Subject: Draft Environmental Impact Report  
New Student Housing Project

**RE: Response to SDSU's New Student Housing Project Draft Environmental Impact Report**

**Response to Comment Letter L5**

## Responses to Comments – Local Agencies

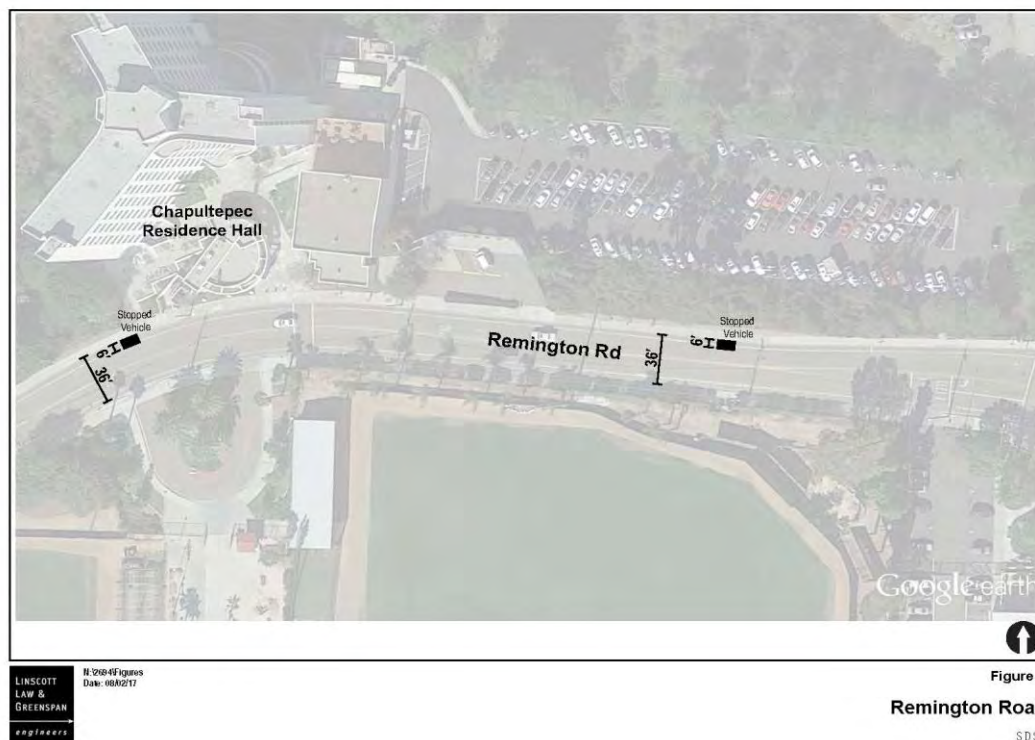
Section 4.14.6.11, Emergency Response Times, Page 4.14-47. This section assumes there is adequate room for Emergency Vehicles (EV) to maneuver. It is recommended that an exhibit to show dimensions for adequate space for EV egress and ingress during peak time traffic be included to substantiate these conclusions within the DEIR.

Emergency Response Times, Page 4.14-48. "Even assuming cars are illegally parked on one side of the street, this leaves approximately 30 feet of roadway, which is a sufficient width for cars traveling in opposite directions to pull over next to the parked car and for the emergency vehicle to pass." This assumes there is no opposite direction traffic. If vehicles are parked illegally, and traffic is flowing in both directions, EVs may not have 30 feet to maneuver. Provide an exhibit to show the dimensions under the worst-case, and likely scenario that you have described, and demonstrate that there is adequate space for EV at this worst case scenario to substantiate the conclusion within the DEIR.

**L5-13** The comment requests an exhibit to show adequate space for emergency vehicle ingress and egress on Remington Road. Please see the response to comment L-5-14 for information responsive to this comment.

**L5-14** The comment requests an exhibit to show that under the scenario in which cars are illegally parked and traffic is flowing in both directions, emergency vehicles have sufficient space to maneuver. Remington Road is about 36 feet wide along the frontage of the proposed Project. This leaves about 30 feet of width if a vehicle is parked illegally. If vehicles heed to the emergency vehicle flashing lights and sirens and move to the curb as required by law, there is ample room for emergency vehicles to pass, as shown on Figure A.
